Re: **Summit Drive Properties LLC**
Summit Drive
Town of Marlborough, New York
Site Plan Application
SBL: 108.4-6-29.311

SITE PLAN

DRAWN BY	CHECKED BY
MLT	
DATE	SCALE
09/22/23	1"=30'
PROJECT NO.	
23006	
SHEET NO.	
SP-1

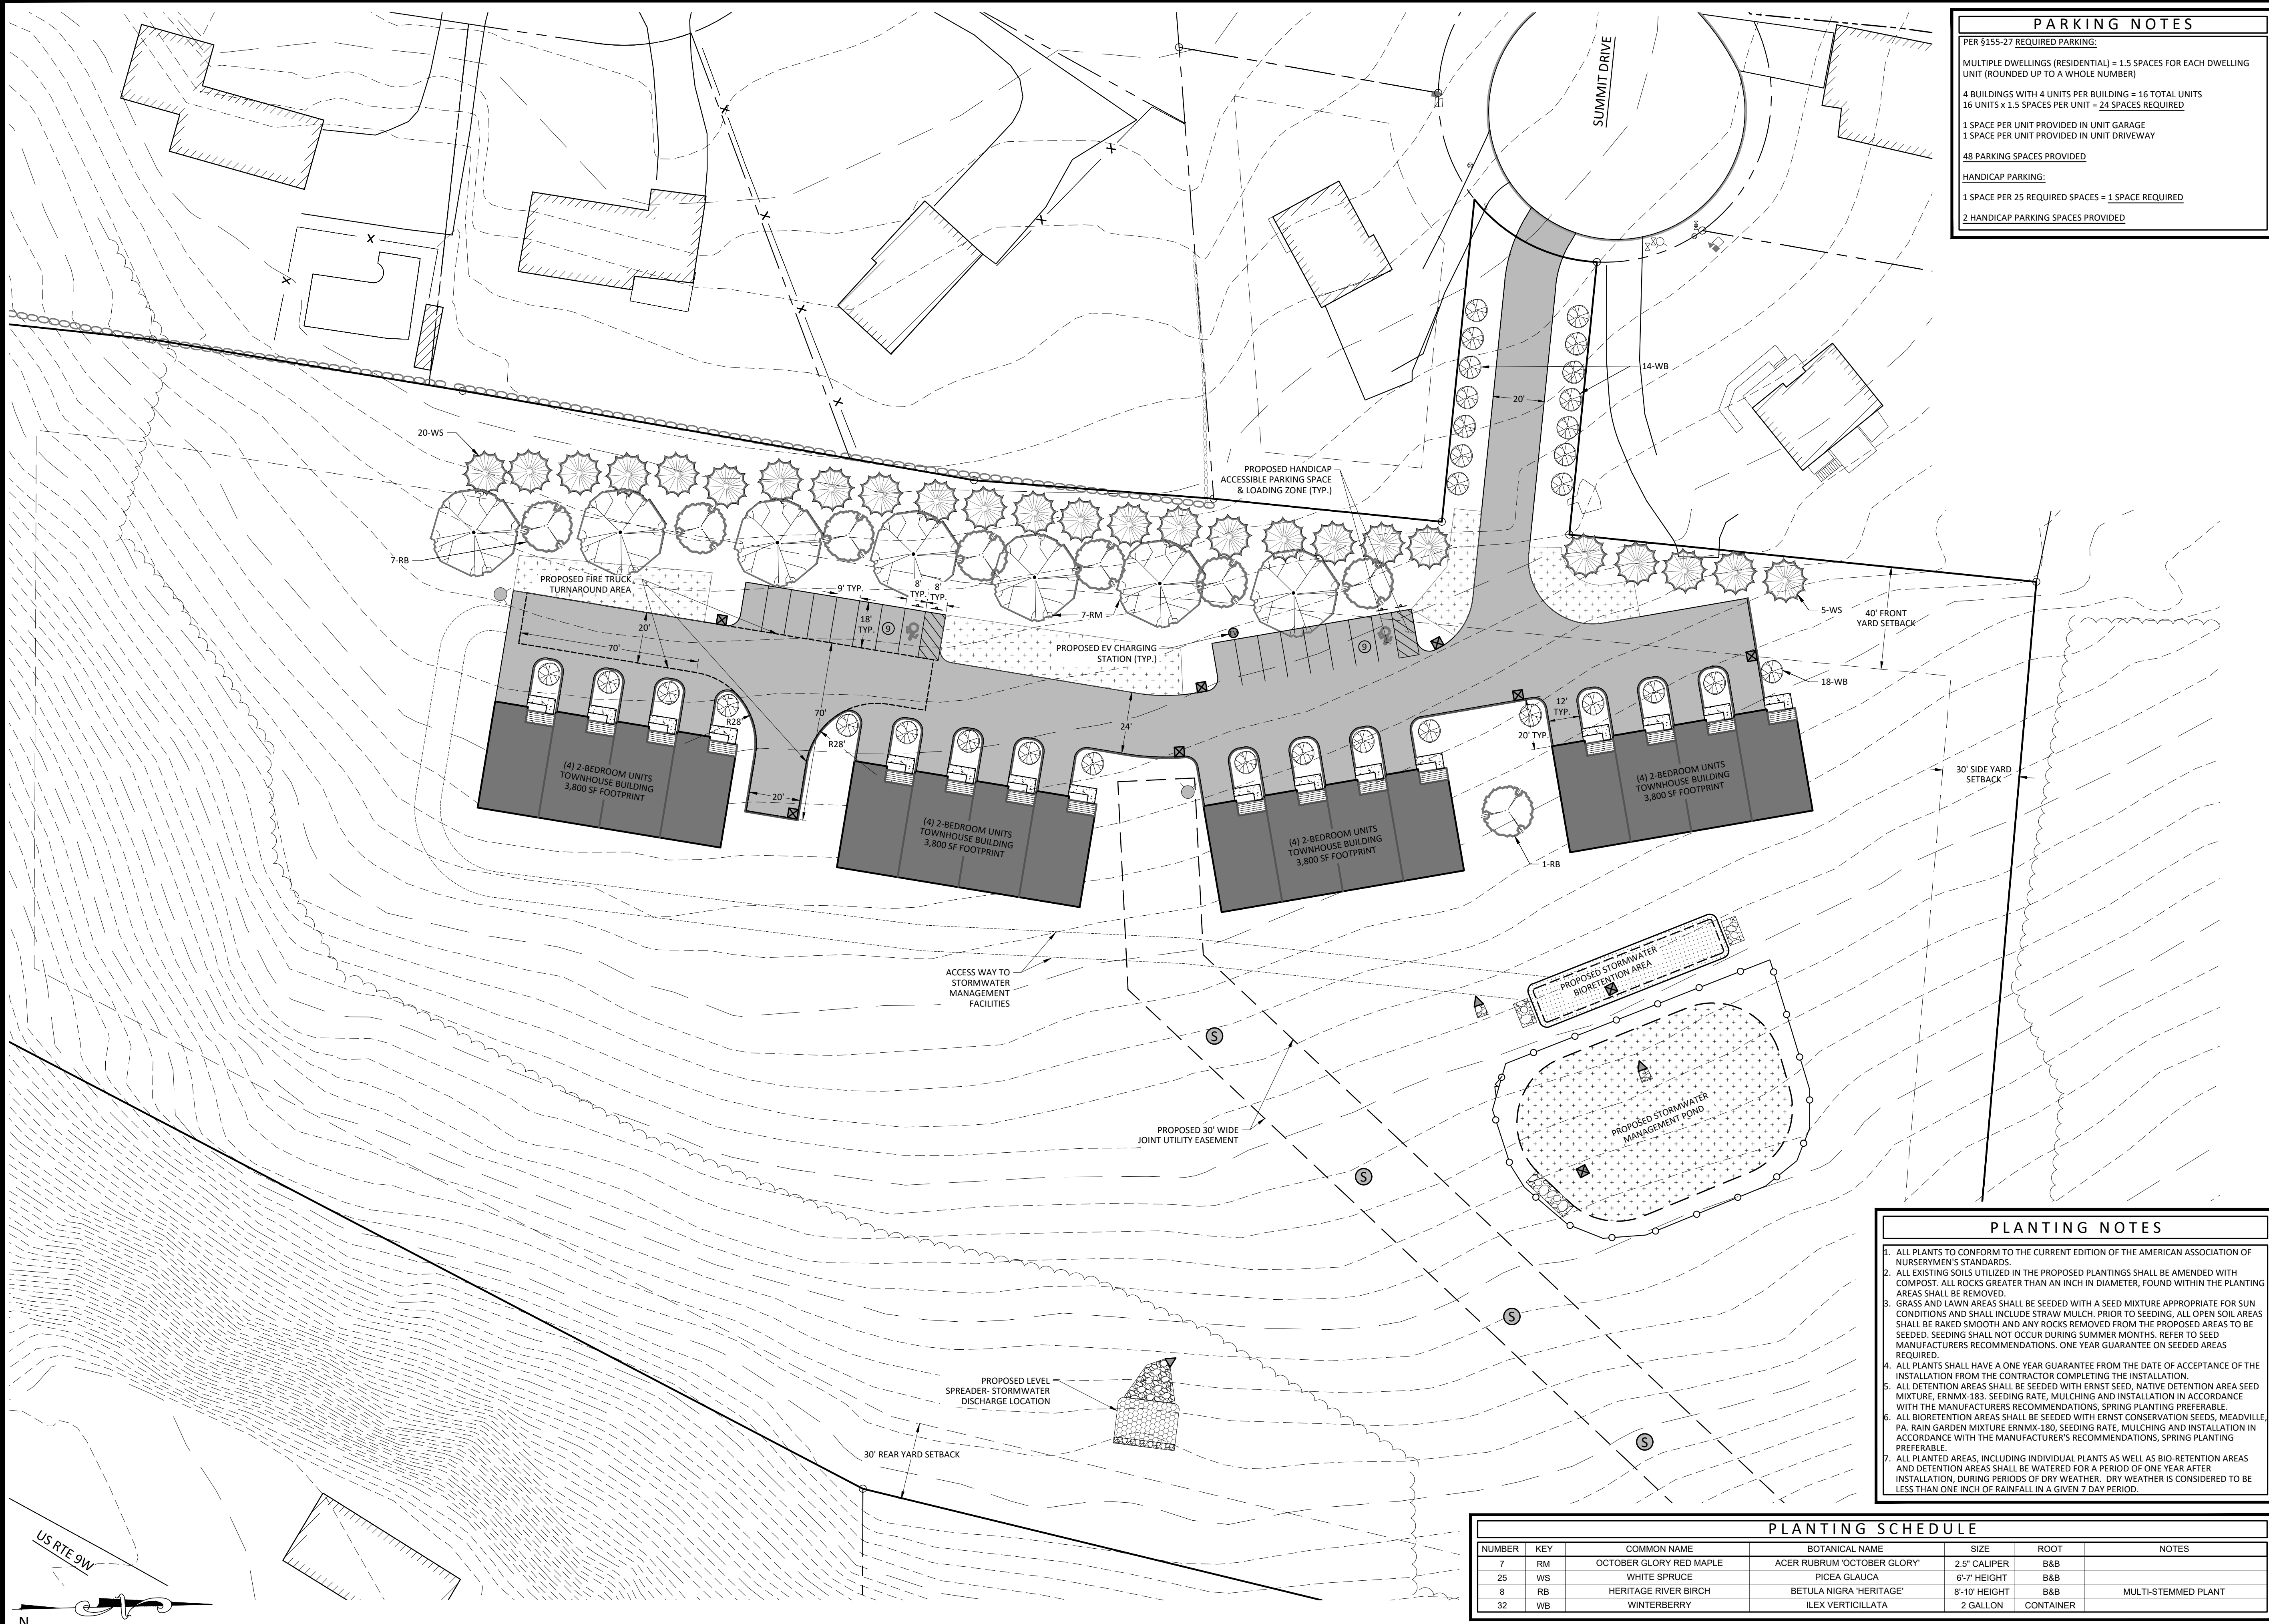
Significant changes to the project involve reverting site access back to Summit Drive, as it was determined at the workshop meeting that the option to access the project from Grand Street is infeasible for various reasons. The other major change to the plan is changing the buildings from multifamily to townhomes. Four townhome buildings are proposed for construction, with each building containing four units (16 total units at the site). Each unit contains 2 bedrooms, for a total of 8 bedrooms per building, and 32 bedrooms total at the site. The previous multifamily plan proposed 24 units at 2 bedrooms each unit for a total of 48 bedrooms so the number of units and bedrooms are being reduced by 33% in the current proposal.

Additional changes to the plan include eliminating centralized refuse collection areas, with each dwelling unit proposed to have individual refuse cans to be stored within unit garages. Parking for the site includes one space in each garage, one space in each driveway (which provides access to each garage) and 16 additional spaces, for a total of 48 spaces being provided, well beyond the 24 spaces required by code. An emergency vehicle turnaround area is provided in accordance with NYS Fire Code.
